Application Summary

Application ID	25040461
Proposal	Five-level residential flat building containing 14 dwellings, basement car parking and landscaping
Location	3 PATAWALONGA FRTG GLENELG NORTH SA 5045

Re: 3 PATAWALONGA FTG GLENELG NORTH SA 5045
Application ID: 25040461
Residential Flat Building

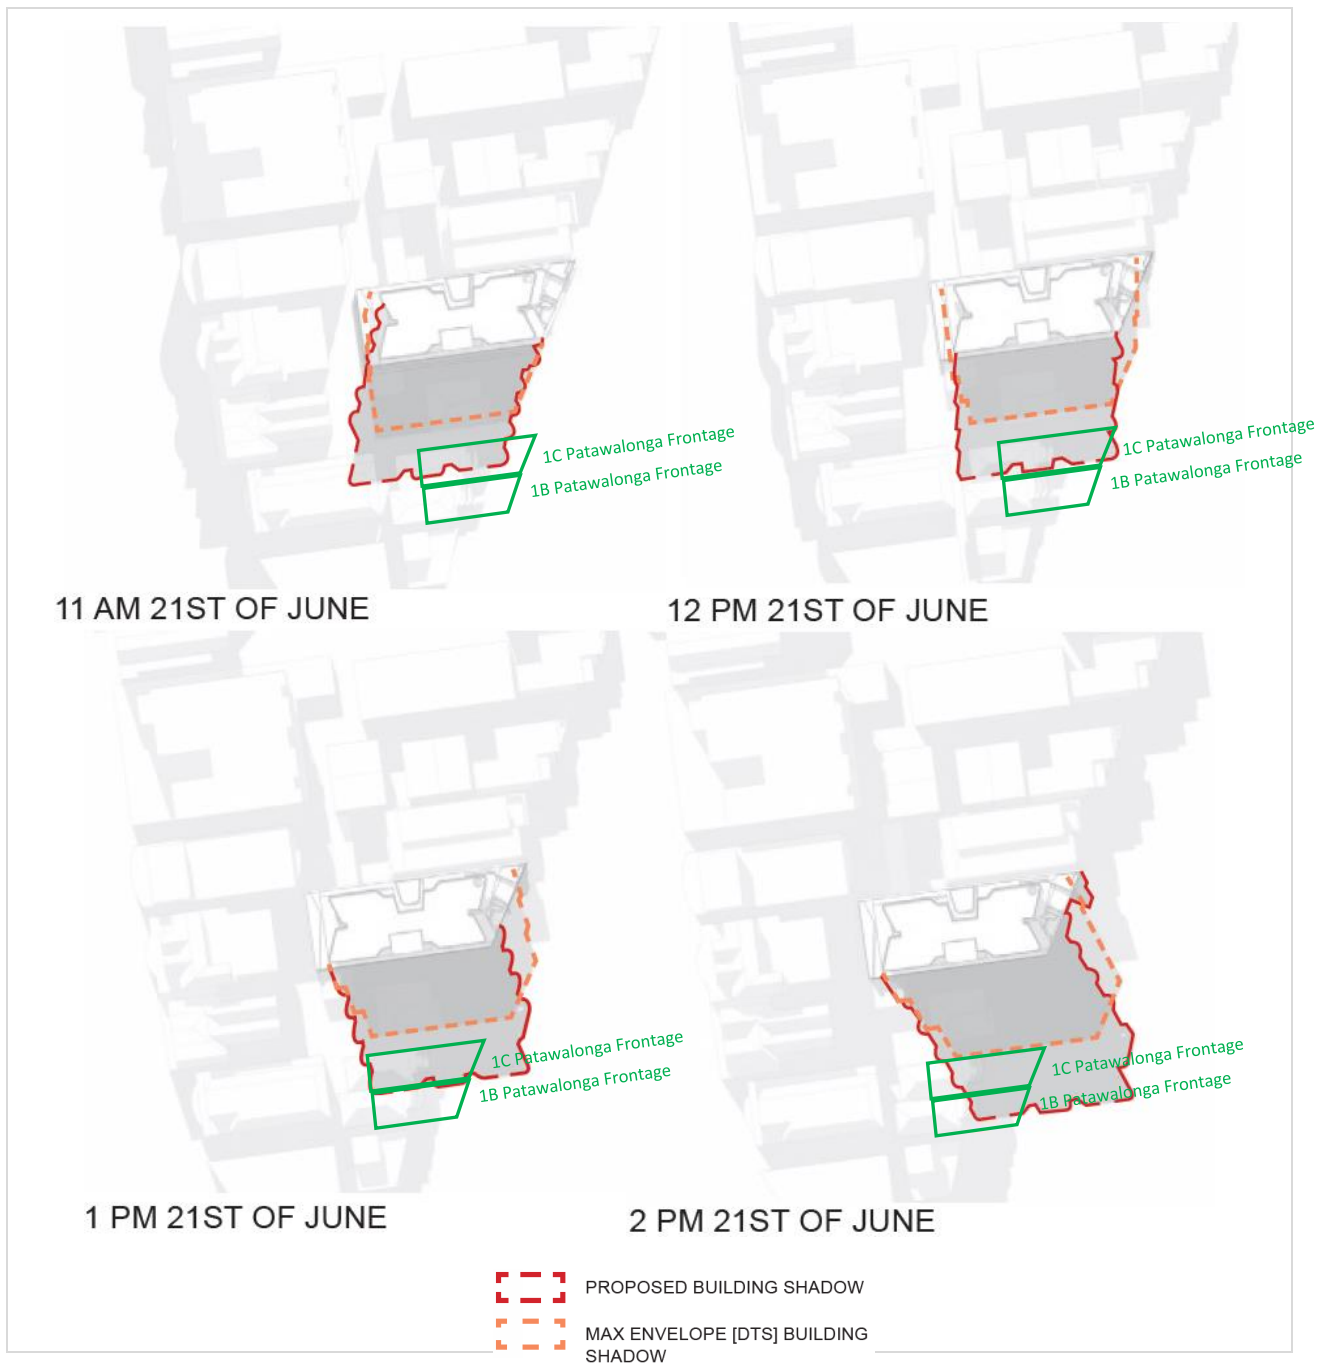
The street adjacent 3 Patawalonga Frontage will have resident cars parked in it virtually all the time. This means the hard rubbish truck will block the road every Friday for extended periods (for driver to wheel two bulk 660 litre rubbish bins out, empty them, and wheel back in) and the recycling rubbish truck will block the road every second Friday for a longer extended period (for driver to wheel three bulk 660 litre rubbish bins out, empty them, and wheel back in). This will be an

extended traffic hazard for all vehicles using this section of Patawalonga Frontage during these times.
